ADDENDUM TO INVITATION TO BID

PROJECT: **BID #D00424 – STAUNTON CROSSING – ELEVATED WATER STORAGE TANK**

DATE: **MAY 9, 2024**

ADDENDUM: **1**

JOB NO.
49408
SHEET NO.
T2.0

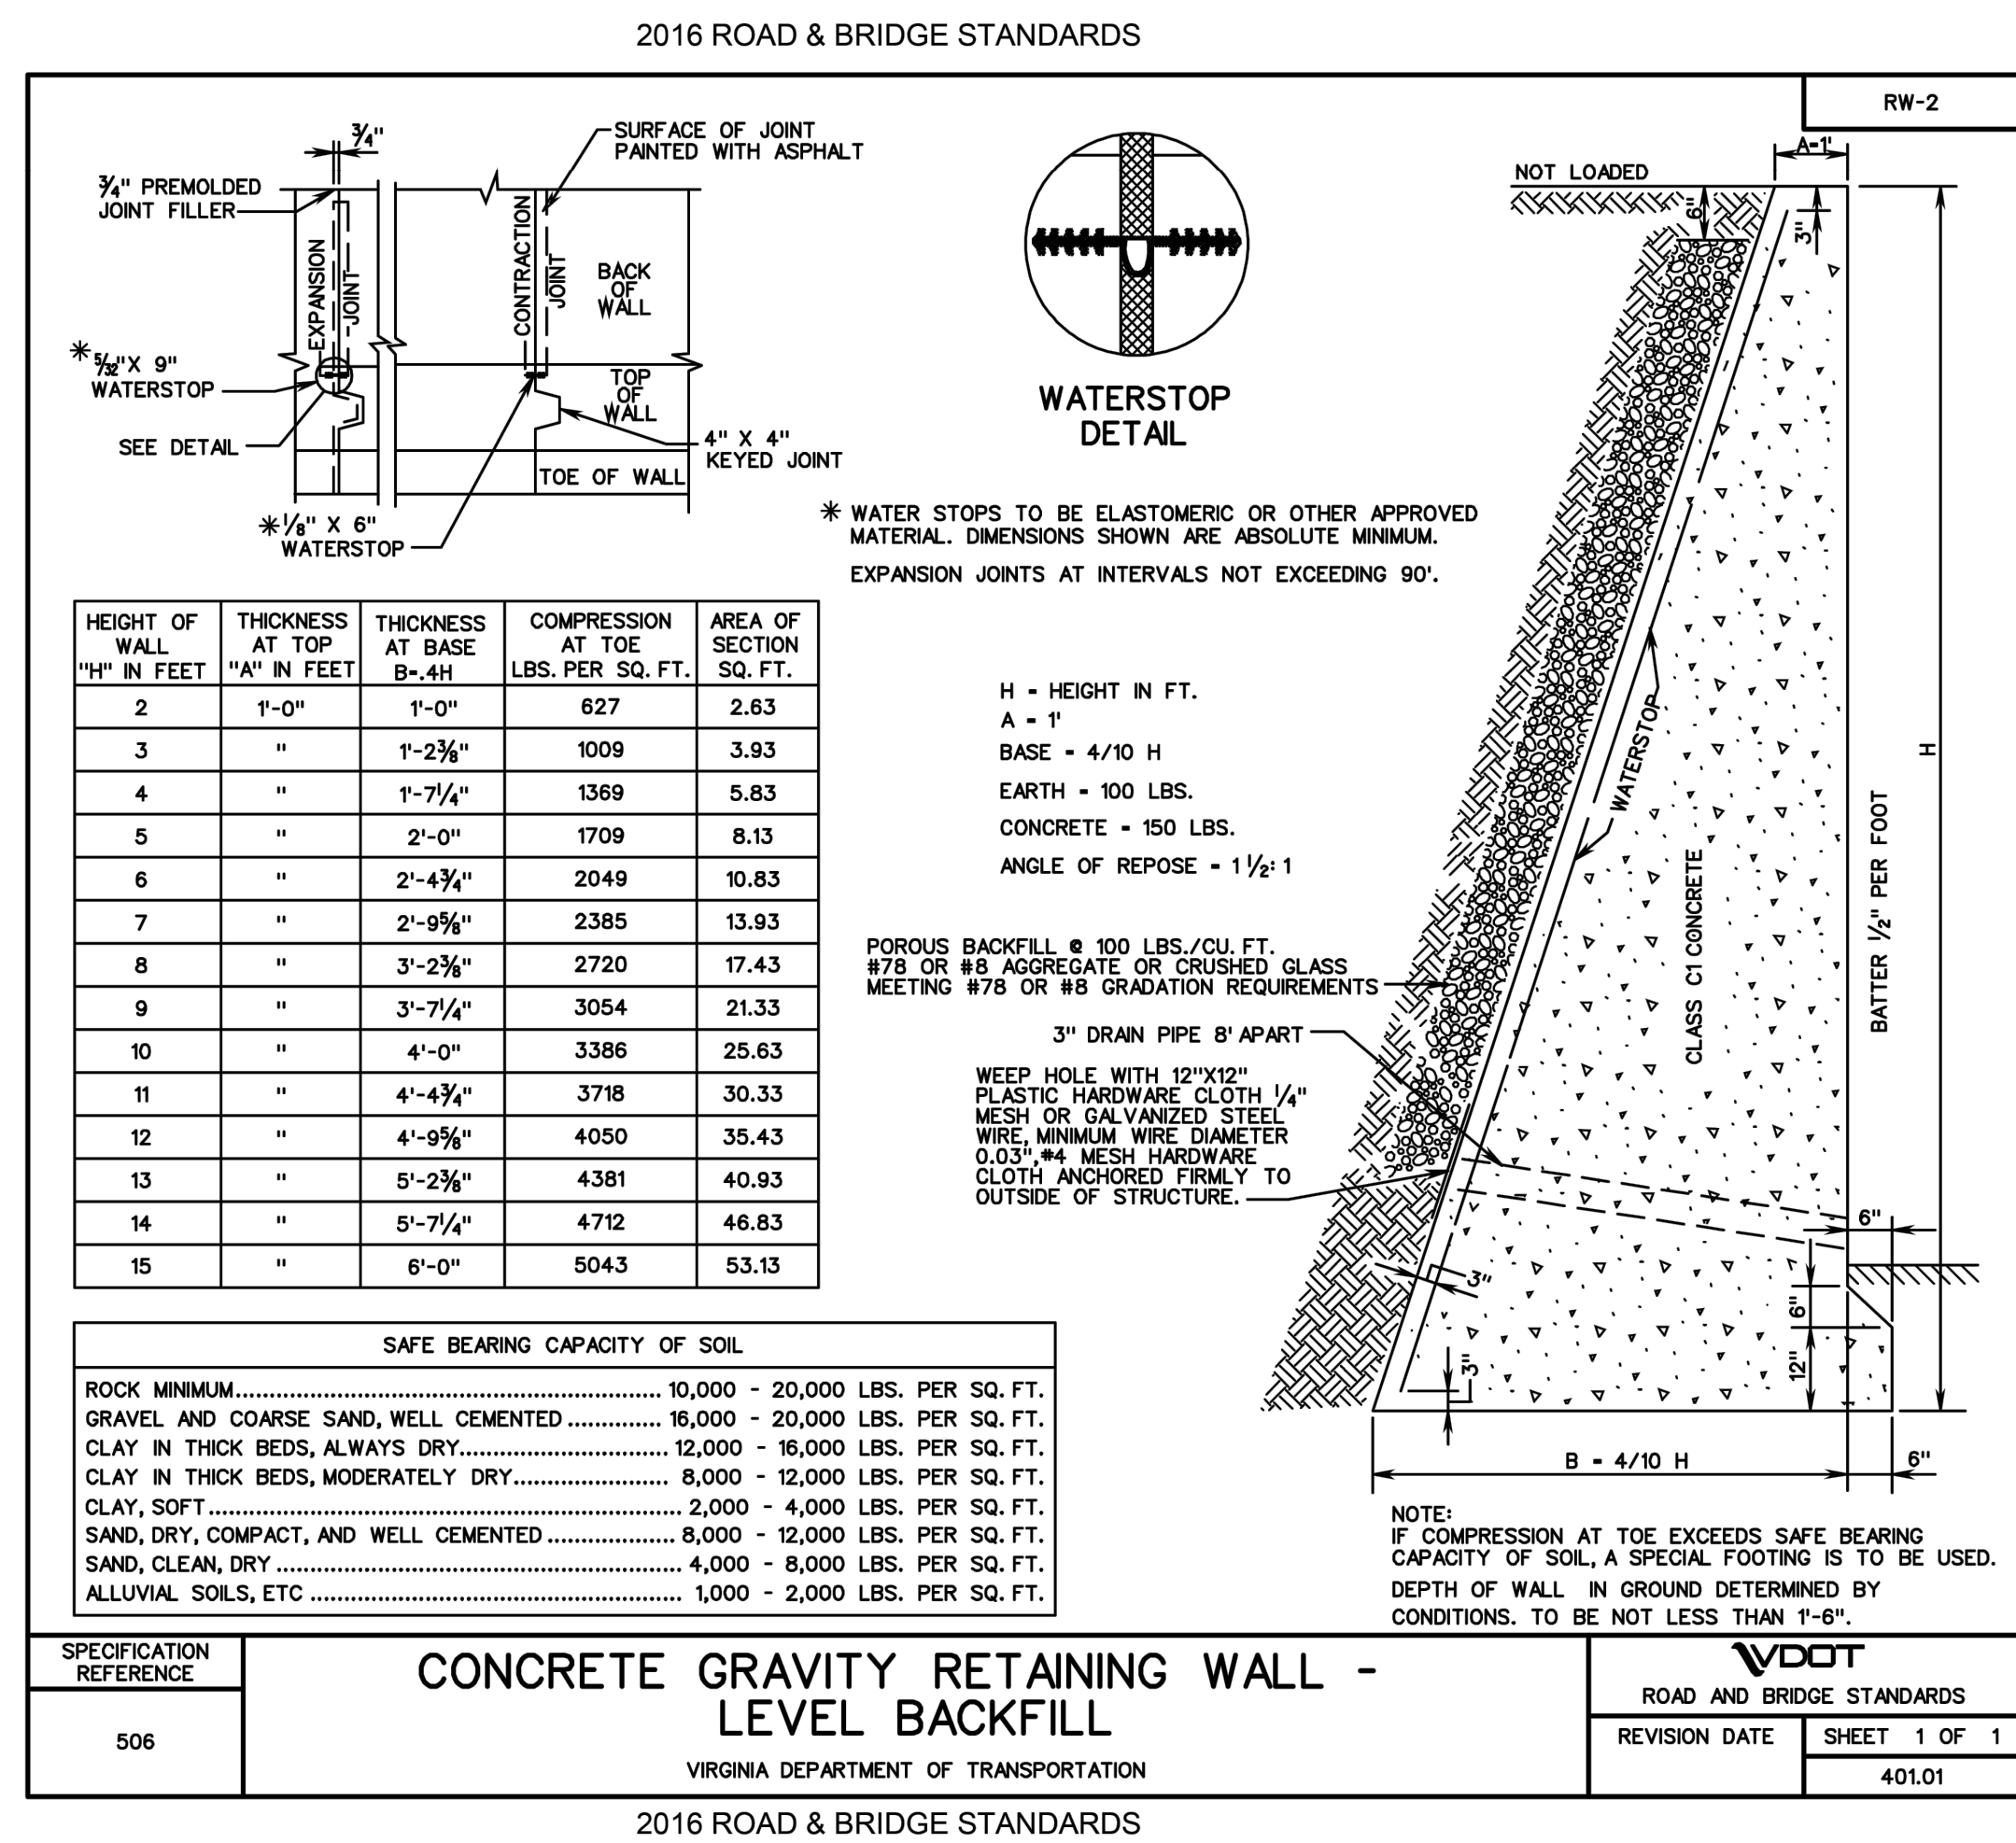
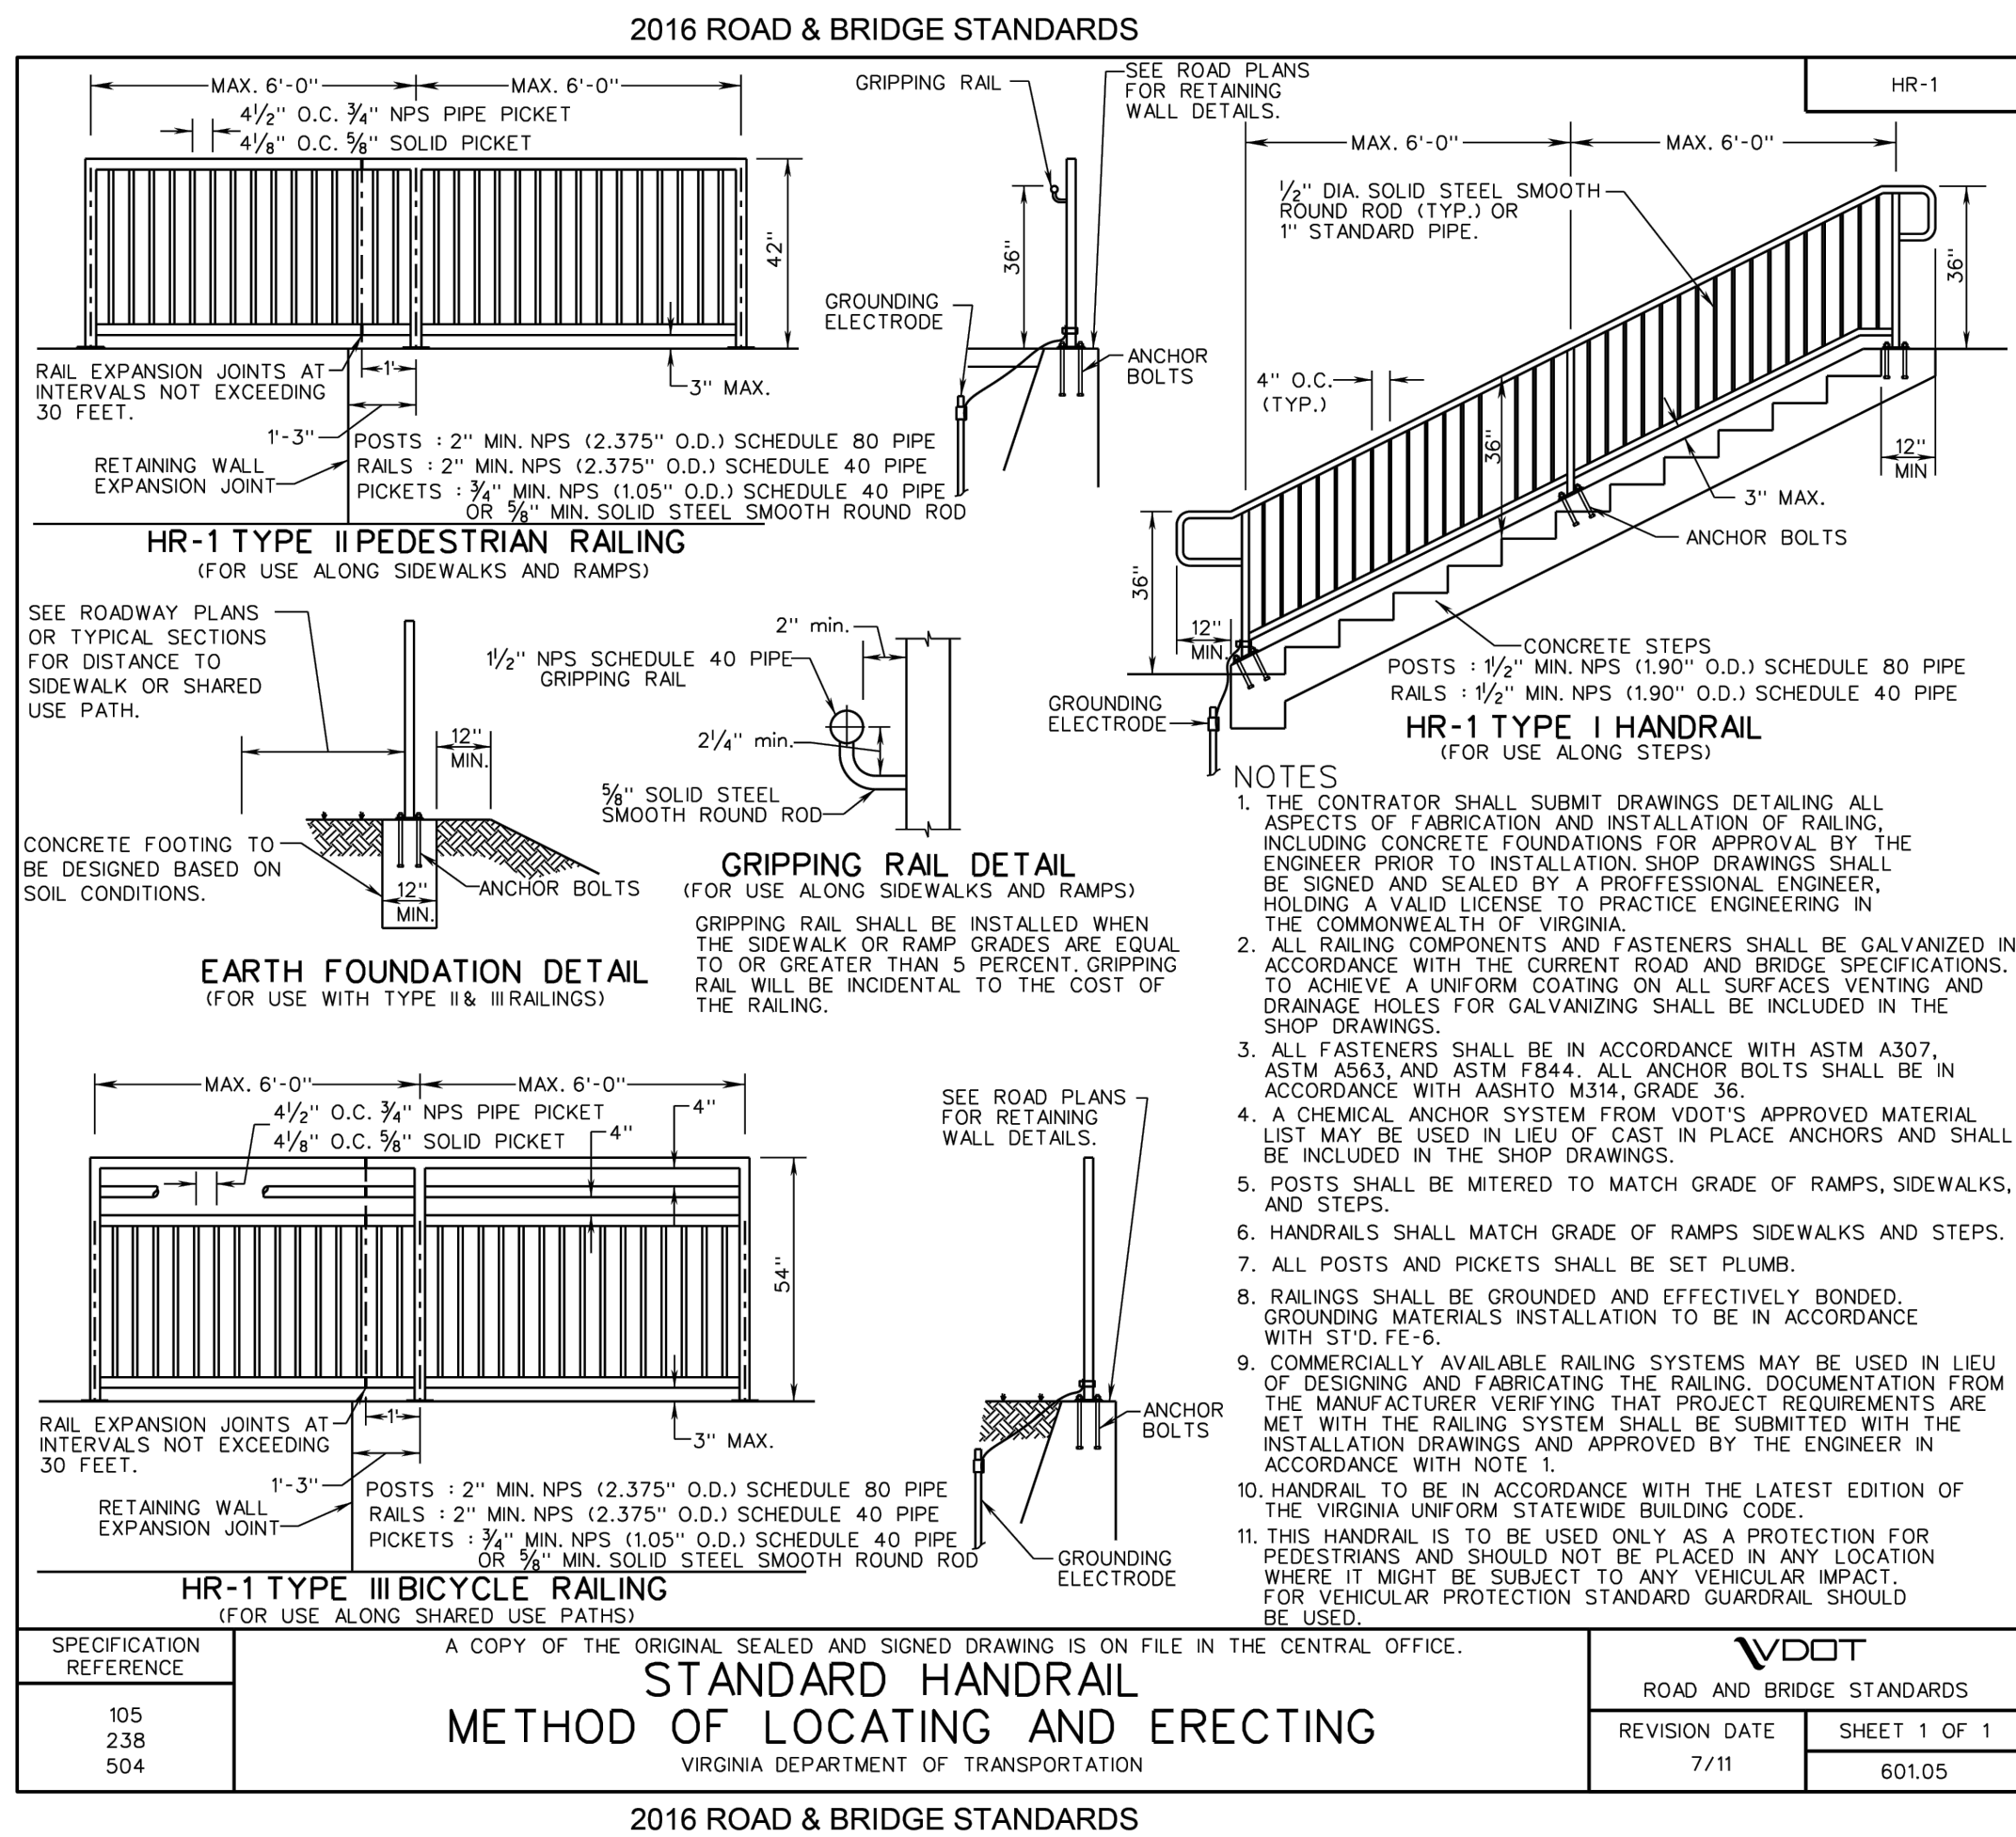
6. Is there any design for the retaining walls?

18. Item 1.3 D discusses the Anniversary Inspection. Please verify that the Owner will supply the water for the re-filling of the tank after the inspection.

45. Sheet T1.0 – Plan notes indicate an 8'-0" security perimeter fence is shown to be installed. Sheet T2.0 Fence details indicate a 6'-0" perimeter fence is to be installed. Can you confirm the security fence height is to be 6'-0"?

Response: Please refer to revised Drawings T1.0 and T2.0 for retaining wall details.

Response: Please refer to Concrete Generator Pad detail on Drawing T2.0.

Response: The security fence shall be 8'-0". Please refer to the updated detail on sheet T2.0
